A47 Blofield to North Burlingham

Volume 8 **8.13 Statement of Common Ground** **with National Highways** **and Blofield Parish Council**

Statement of Common Ground – Blofield Parish Council

Regulation Number:	Rule 8(1)(e)
Planning Inspectorate Scheme Reference	TR010040
Application Document Reference	8.13
BIM Document Reference	HE551490-GTY-LSI-000-RP-TX-30045
Author:	A47 Blofield to North Burlingham Dualling Project Team, National Highways

1. Highways England a. Cucumber Lane Roundabout

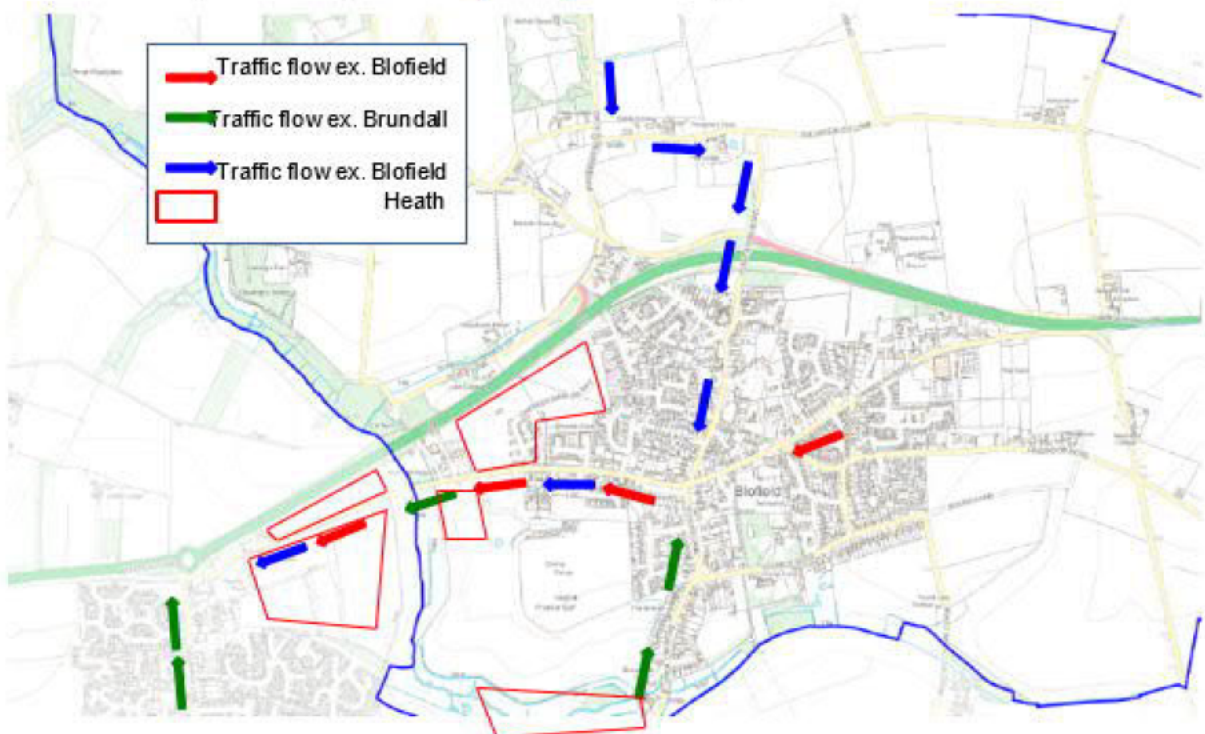
With increased existing and approved residential developments in the villages of Blofield, Blofield Heath and Brundall increased pressure on the village infrastructure continues to mount. Access West towards Norwich from these villages relies, in the main, on access to the A47 dual carriageway at the roundabout at the Cucumber Lane (from Brundall) / Yarmouth Road (from Blofield) junction.

Traffic routes (as indicated on the map) show traffic emanating from Blofield Heath, Brundall and Blofield itself all concentrating on this junction. Already traffic on the A47 approaching from the East (Acle / Gt. Yarmouth) approaches the junction at high speed and volume causing congesting at the roundabout for traffic joining from the villages, causing tailbacks at peak times.

Both Highways England and Norfolk Highways refuse to perceive this as a problem either now or in the future and have resisted taking a proactive approach to the problem by planning ahead instead positioning themselves on a "wait and see" approach.

b. Traffic flow through the village

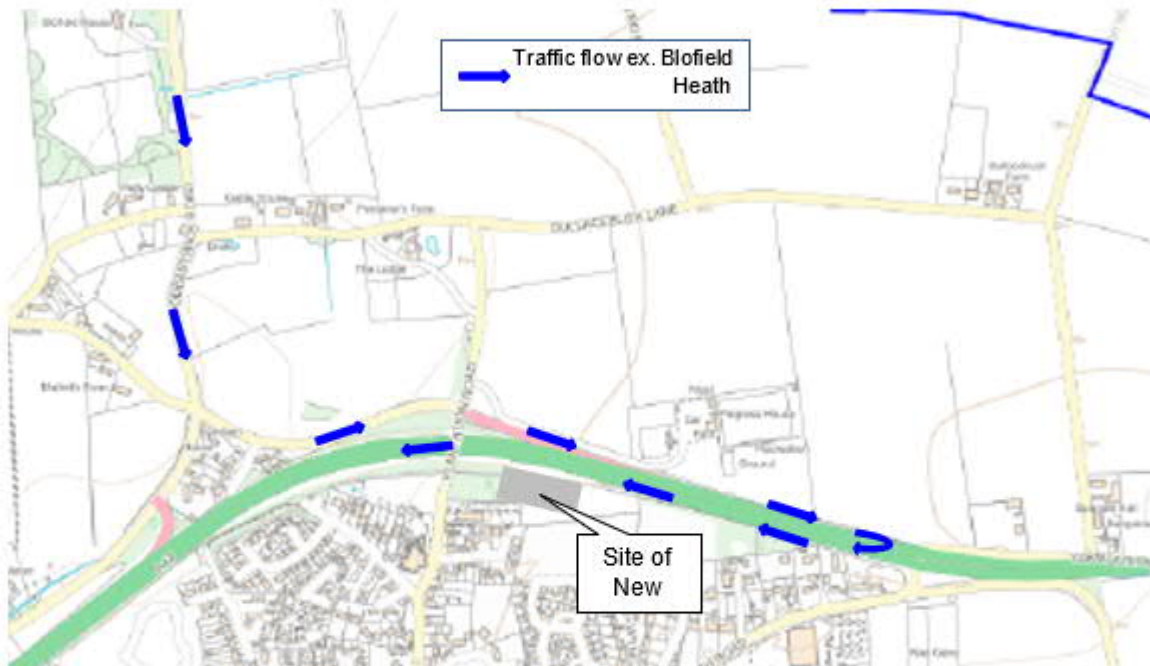
During Consultation with Highways England on the proposed plans for dualling from Blofield to North Burlingham it became apparent that a reasonable number of Blofield Heath residents were travelling south out of their village towards Blofield, using the slip road to join the A47 East towards Acle and using the gap in the central reservation (access to east end of Blofield) to execute a U-turn at this junction to join the A47 WEST towards Norwich.

As part of the dualling scheme Highways England plan to close this break in the central reservation therefore closing off this access route towards Norwich. The consequence of this is to force all of the traffic from Blofield Heath through the already congested village of Blofield and along Yarmouth Road to the Cucumber lane roundabout (see 1a above).

Norfolk County Council also plan to build a new primary school in the next 2-3 years at the location shown on the map that is at least DOUBLE the size of the existing school thus creating even more traffic along a typical village road. As NCC had, at the point of the consultation with Highways England, not yet submitted planning applications, HE were unaware of this until advised by the Parish Council. They committed to consider this in their planning.

Blofield East Modified A47 Junction Suggestion

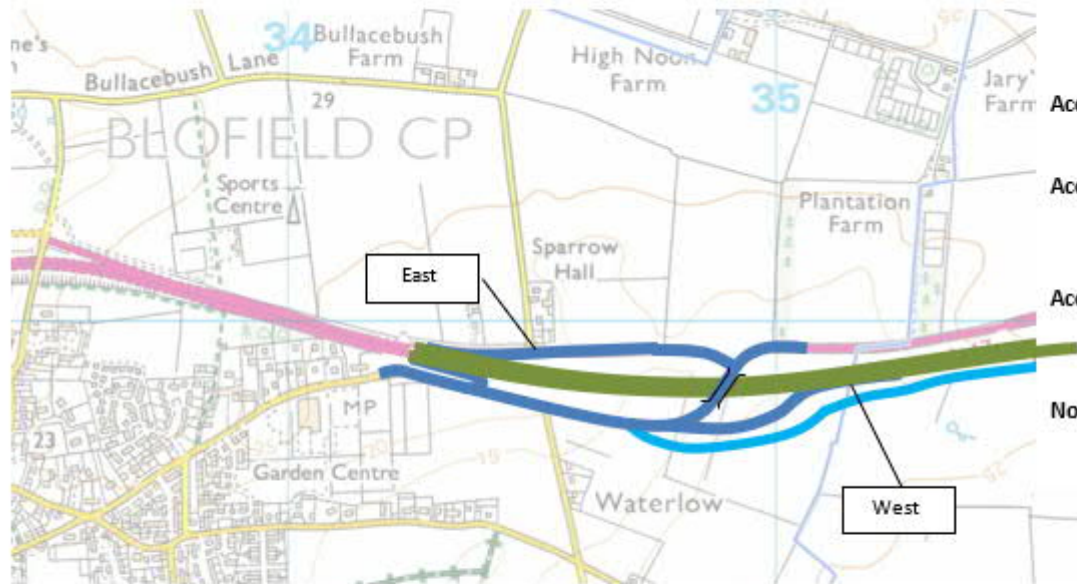
Following the meeting Blofield Parish Council proposed the alternate junction (see below) at the eastern end of Blofield that would potential alleviate both of the issues above.

This was submitted to Highways England for consideration (as it was felt only minor changes were required) but has been completely ignored and discounted in the final plans and submission of the DCO.

Figure 2

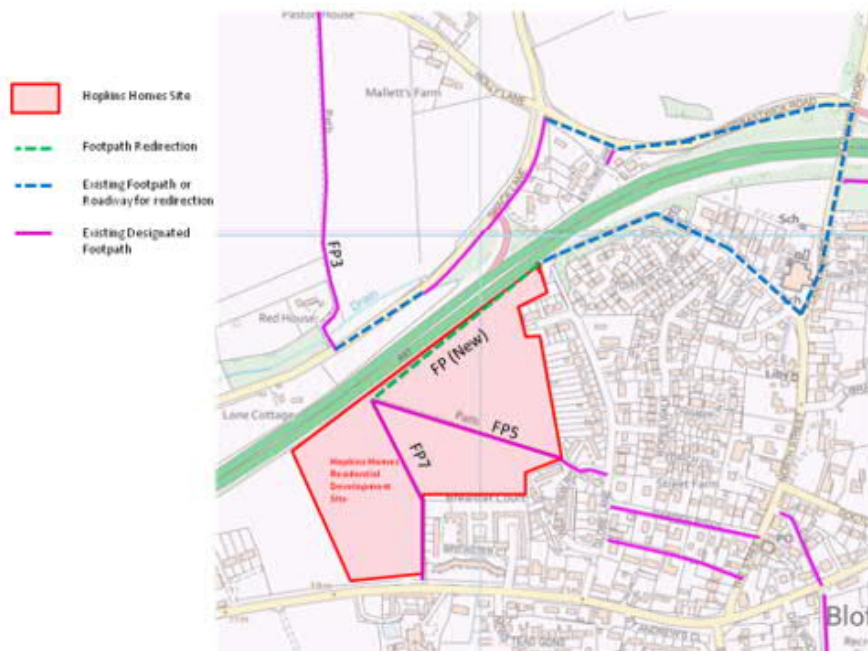
As a consequence of the above the Council is proposing to seek redirection of the footpath as outlined in Figure 2 below.

Due to limited crossing points of the A47 the redirection would be as follows :

- Establishment of new recognised footpath along the Northern Boundary going north-east to join existing footpath to North Street.
- South-east along pavement to Plantation Road
- North along Plantation Road, crossing A47 over roadway bridge
- West on Woodbastwick Road
- South-west on Shack Lane to rejoin FP3 at existing point

2.3 Works Plans

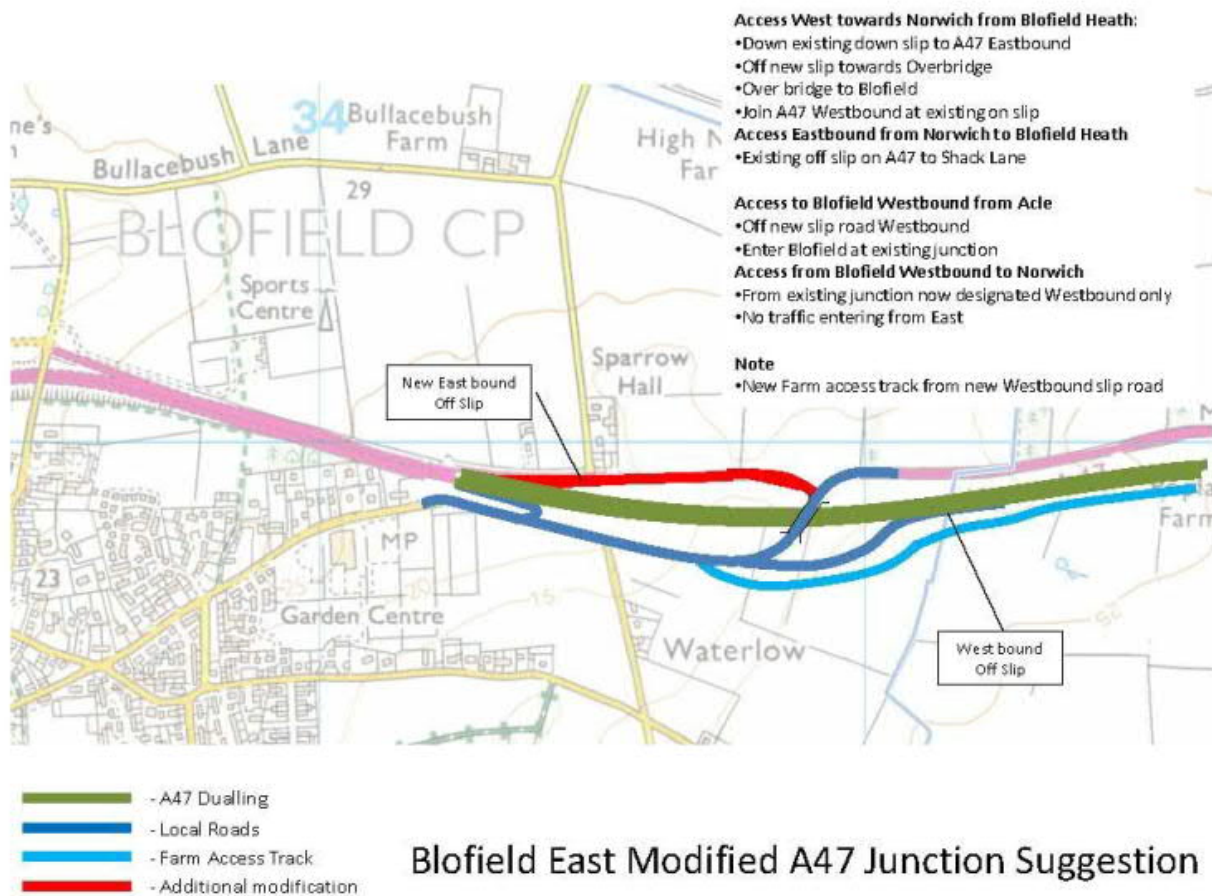
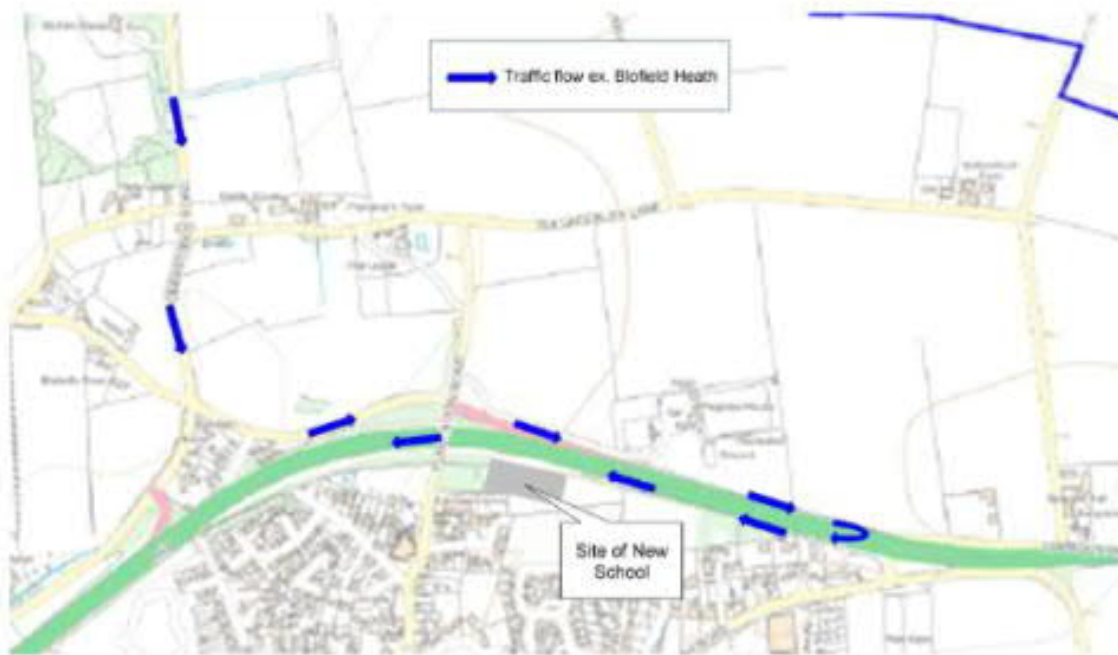
Blofield Parish Council is disappointed that the suggested alternative junction layout has been completely disregarded by Highways England.

Traffic flow from Blofield Heath suggests that a high number of parishioners are exiting Blofield Heath, travelling south towards Blofield, using the slip road to join the A47 East towards Acle and then using the gap in the central reservation to execute a U turn to then travel to towards Norwich on the westbound A47, as indicated below.

As the proposal for the A47 junction will close off the gap in the central reservation, it is our view that traffic will be forced to enter Blofield and encounter the already congested road network in the vicinity of the current school site, doctors surgery and proposed new school site for onward travel to the A47 Cucumber Lane roundabout for onward travel to Norwich.

It is with this knowledge why we proposed an alternative layout to the junction that could be achieved with minor alterations to the plans which, in our view, would alleviate the traffic flow issues demonstrated above.

Page 3 : Cucumber Lane Roundabout: Therefore, the implementation of the Scheme is not the underlying reason for the capacity related operational issues at the junction. **It may not be the underlying reason but shouldn't a scheme also try to resolve a recognised problem**

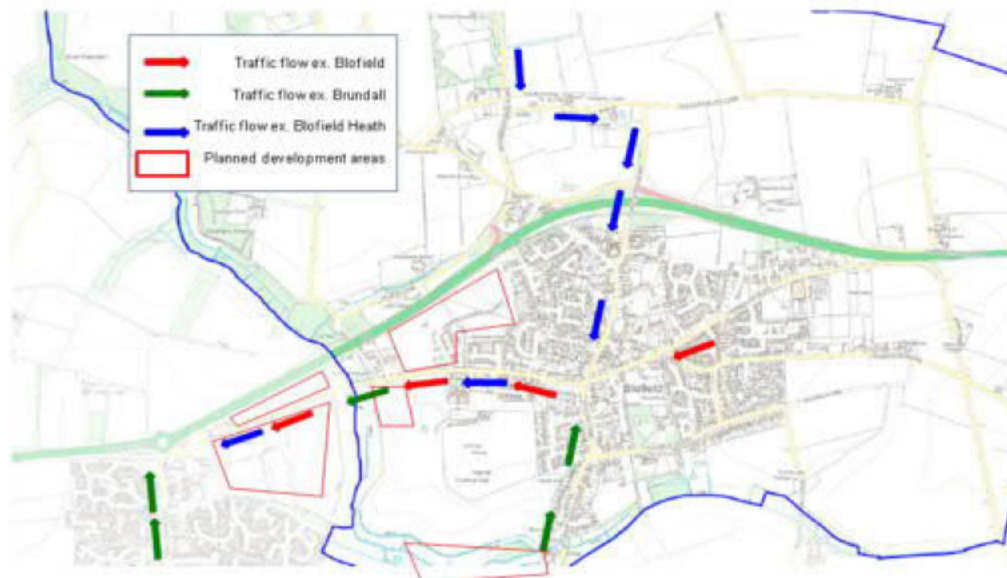
With increased existing and approved residential developments in the villages of Blofield, Blofield Heath and Brundall increased pressure on the village infrastructure continues to mount. Access West towards Norwich from these villages relies, in the main, on access to the A47 dual carriageway at the roundabout at the Cucumber Lane (from Brundall) / Yarmouth Road (from Blofield) junction.

Traffic routes (as indicated on the map) show traffic emanating from Blofield Heath, Brundall and Blofield itself all concentrating on this junction. Already traffic on the A47 approaching from the East (Acle / Gt. Yarmouth) approaches the junction at high speed and volume causing congesting at the roundabout for traffic joining from the villages, causing tailbacks at peak times.

Both Highways England and Norfolk Highways refuse to perceive this as a problem either now or in the future and have resisted taking a proactive approach to the problem by planning ahead instead positioning themselves on a "wait and see" approach.

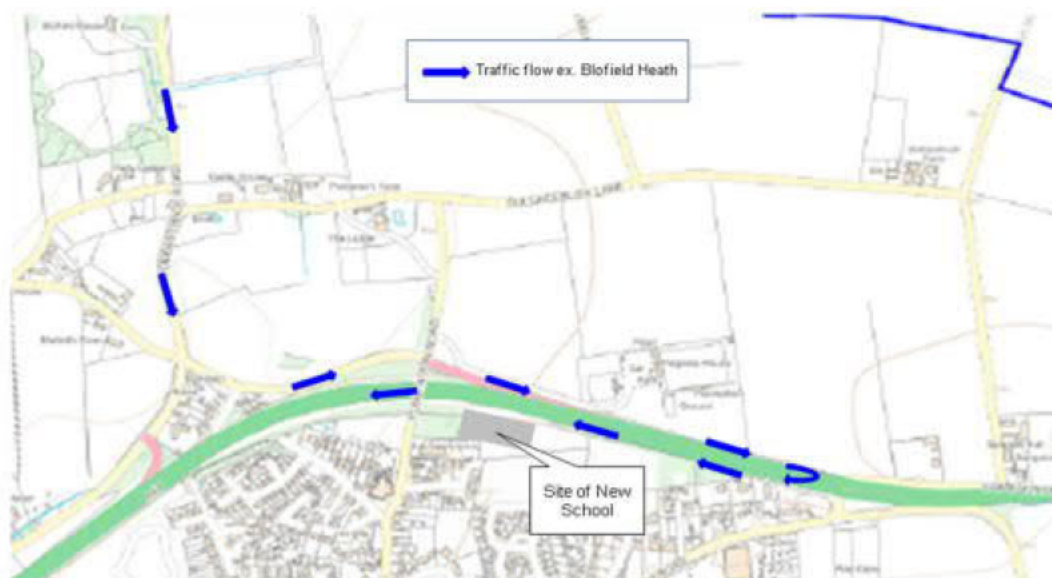
During Consultation with Highways England on the proposed plans for dualling from Blofield to North Burlingham it became apparent that a reasonable number of Blofield Heath residents were travelling south out of their village towards Blofield, using the slip road to join the A47 East towards Acle and using the gap in the central reservation (access to east end of Blofield) to execute a U-turn at this junction to join the A47 WEST towards Norwich.

As part of the dualling scheme Highways England plan to close this break in the central reservation therefore closing off this access route towards Norwich. The consequence of this is to force all of the traffic from Blofield Heath through the already congested village of Blofield and along Yarmouth Road to the Cucumber lane roundabout (see 1a above).

Norfolk County Council also plan to build a new primary school in the next 2-3 years at the location shown on the map that is at least DOUBLE the size of the existing school thus creating even more traffic along a typical village road. As NCC had, at the point of the consultation with Highways England, not yet submitted planning applications, HE were unaware of this until advised by the Parish Council. They committed to consider this in their planning.

Page 7: Yarmouth Road Junction It is still disappointing that the alternative option has been discounted with no discussion with anyone with local knowledge. We will probably have to “agree to disagree”.

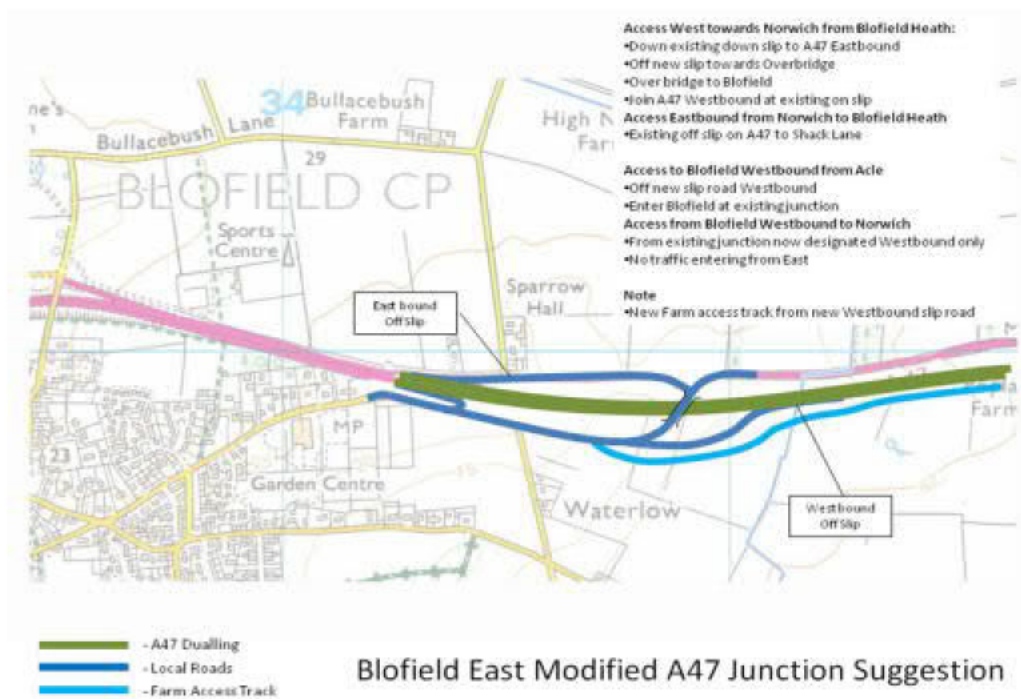
Following the meeting Blofield Parish Council proposed the alternate junction (see below) at the eastern end of Blofield that would potential alleviate both of the issues above.

This was submitted to Highways England for consideration (as it was felt only minor changes were required) but has been completely ignored and discounted in the final plans and submission of the DCO.
